DRIP  
Internet-Draft  
Updates: 7401, 7343 (if approved)  
Intended status: Standards Track  
Expires: 2 October 2022

DRIP Entity Tag (DET) for Unmanned Aircraft System Remote Identification  
(UAS RID)  
draft-ietf-drip-rid-18

Figure 1: HHIT Format

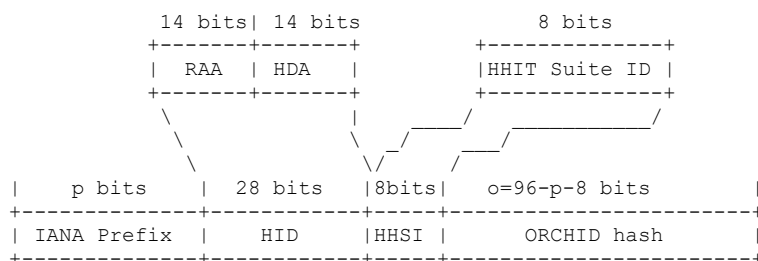
**Commenté [BMI7]:** To cover cases where Network-specific hhits are allowed.

- \* p = [IANA-an IPv6](#) prefix (max 28 bit)
- \* 28-bit Hierarchy ID (HID) which provides the structure to organize HITS into administrative domains. HIDs are further divided into two fields:
  - 14-bit Registered Assigning Authority (RAA) (Section 3.3.1)
  - 14-bit Hierarchical HIT Domain Authority (HDA) (Section 3.3.2)
- \* 8 bit HHIT Suite ID ([HHSI](#))
- \* ORCHID hash (96 - prefix length - 8 for HHIT Suite ID, e.g., 64) See Section 3.5 [for more details](#).
